FRENETTE GARDENS

SB# 03-22 CU #05-22

STAFF REPORT #2

June 22, 2022

DATE: APRIL 20, 2022 SCALE: 1" = 30'
 PROJECT NO: 21-0928-1 SHEET 10 OF 16

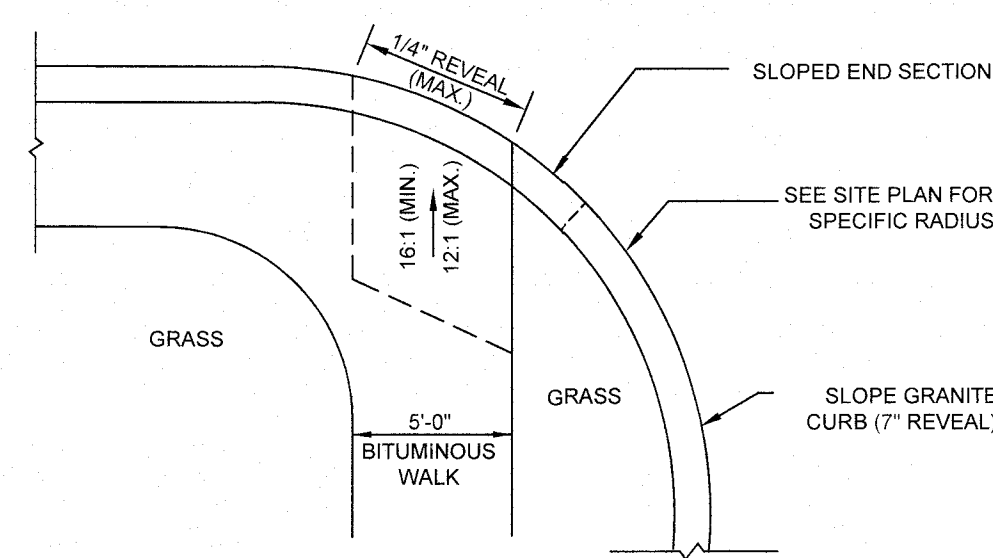
- h. The SMH#5 to Existing Sewer Main Profile should show the proposed water main that crosses the sewer at approximate station 1+95. The applicant should also include a water/sewer crossing detail in the plans.

The proposed water main has been added to the profile (see Sheet 10). Additionally, a water crossing detail has been added to Sheet 14.

PAVEMENT PATCH WITH OVERLAY
NOT TO SCALE

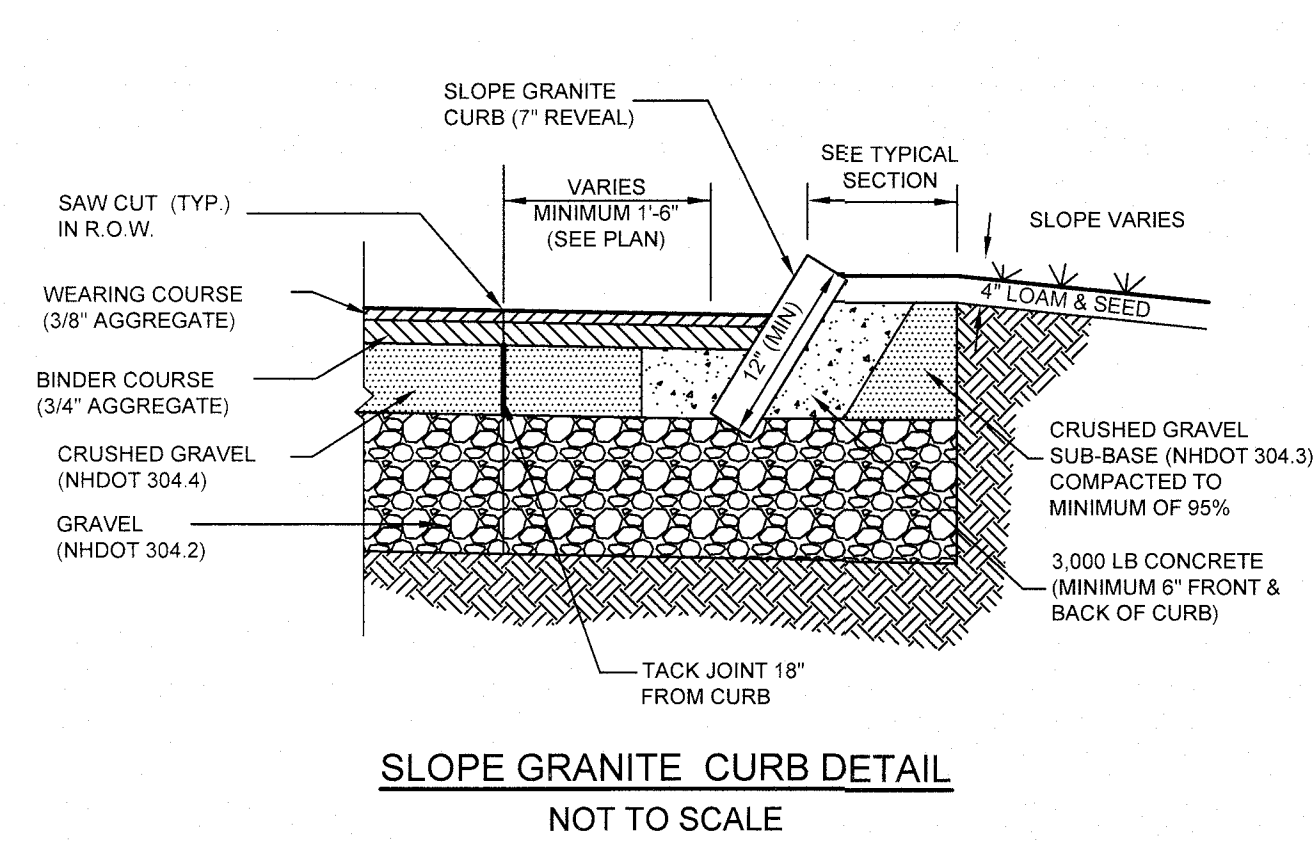
- i. ETGTD Detail R-5. The applicant has proposed a pavement repair detail that doesn't quite match the Town of Hudson detail (base courses should step out 12" beyond the trench width, pavement course cutbacks vary from the detail). The applicant should also coordinate with the Town to show the minimum required pavement depth for the patch across Central Street.

The previous detail has been replaced by the town detail (see Sheet 11).

TYPICAL ROADWAY CROSS SECTION
NOT TO SCALE

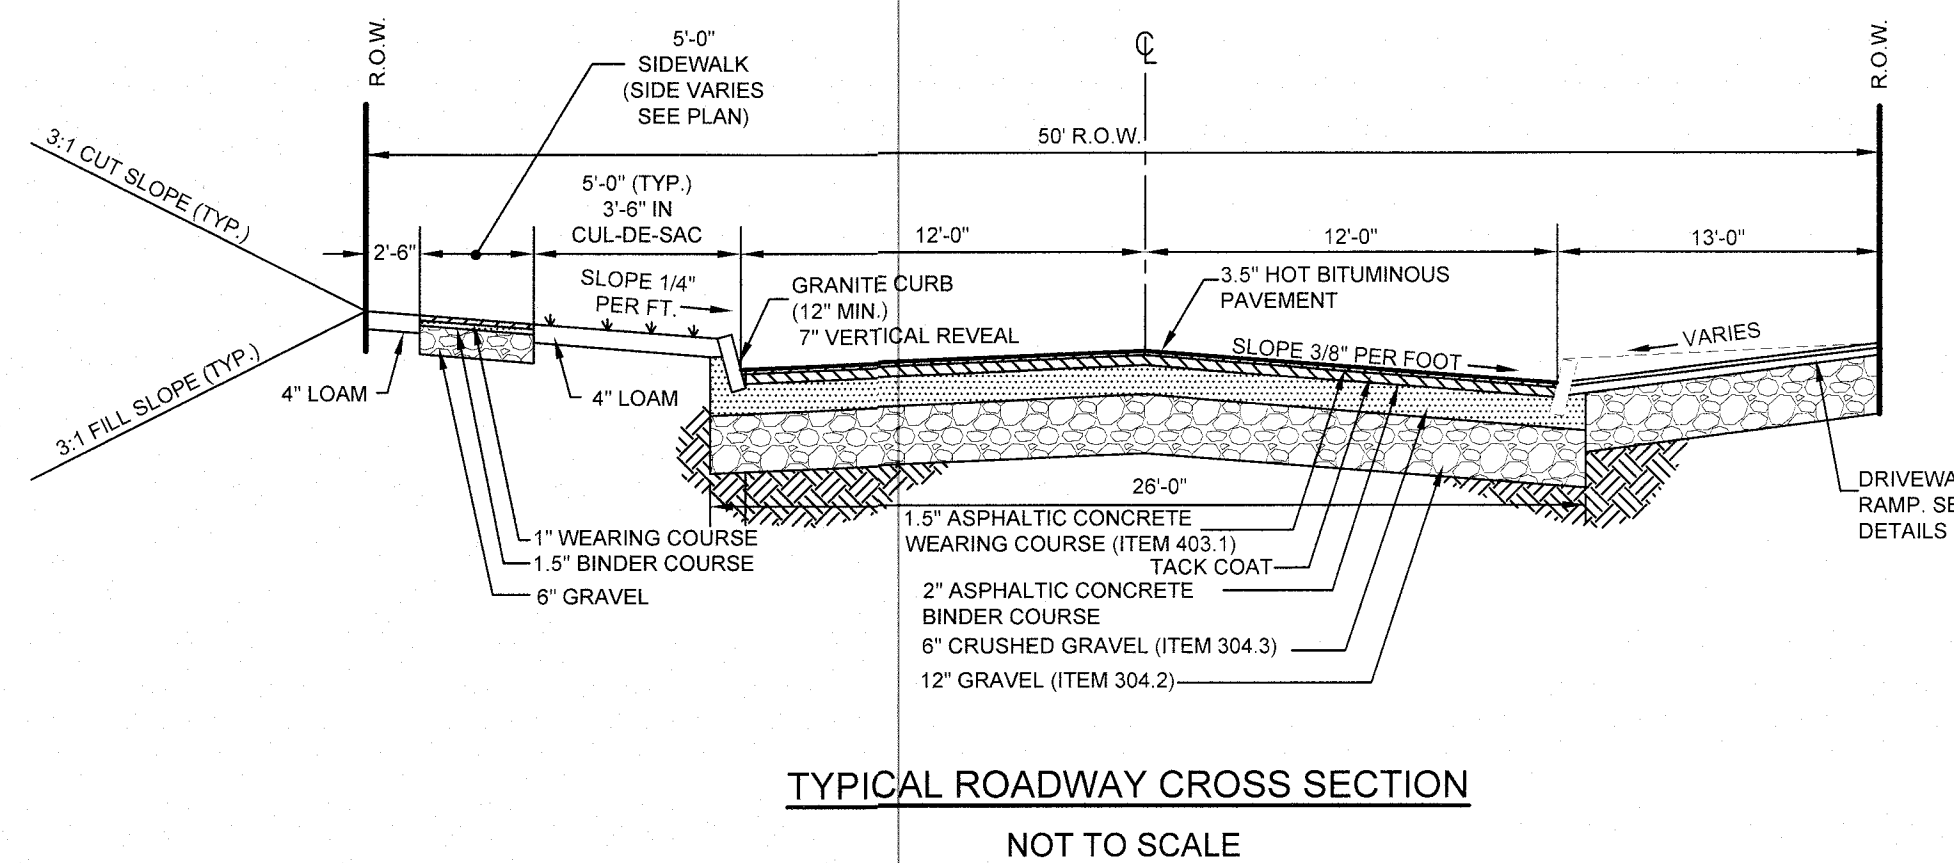
- f. The applicant has proposed a 6.5-foot-wide grass panel between the road and sidewalk. The Town’s standard detail requires a five-foot grass panel. The applicant should confirm with the Town that the wider grass panel is acceptable.

The grass panel has been reduced to 5 feet in the typical ROW and 3.5 feet in the cul-de-sac ROW based on similar comments from the town engineer. The typical roadway section detail on Sheet 11 has been updated accordingly.

INTERNAL DROP SEWER MANHOLE
NOT TO SCALE

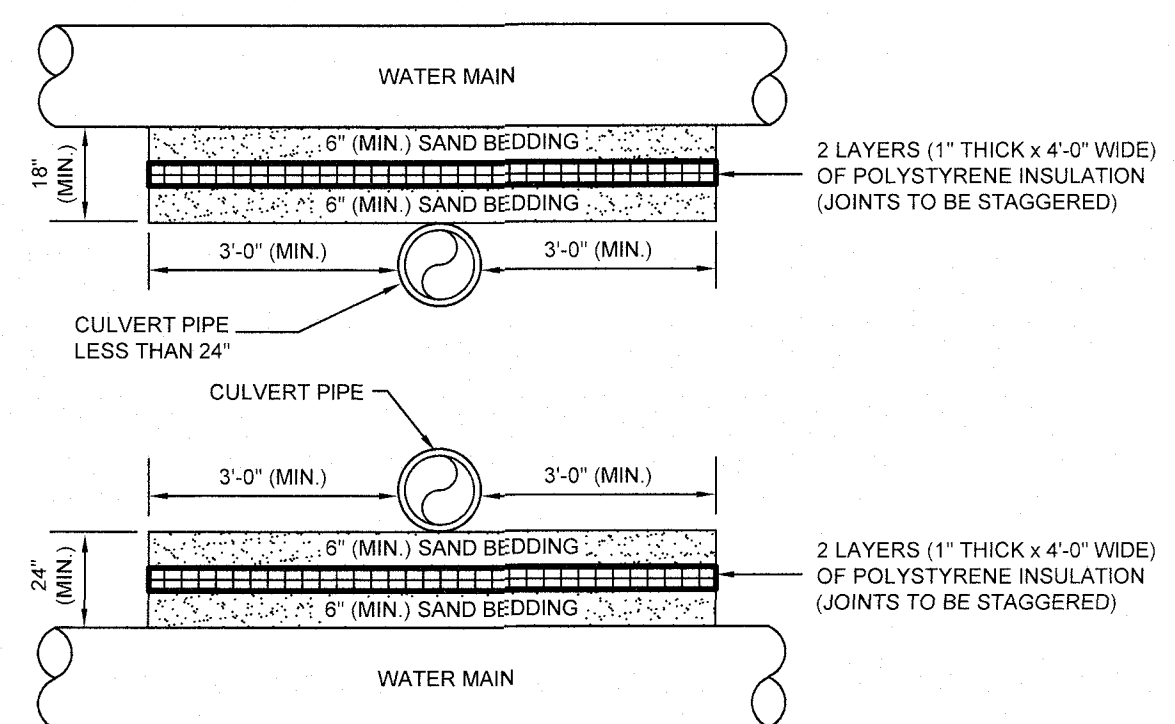
- g. ETGTD Detail S-3. The proposed internal drop sewer manhole doesn't quite match the Town of Hudson detail (cross used at inlet instead of Tee).

The previous detail has been replaced by the town detail (see Sheet 14).
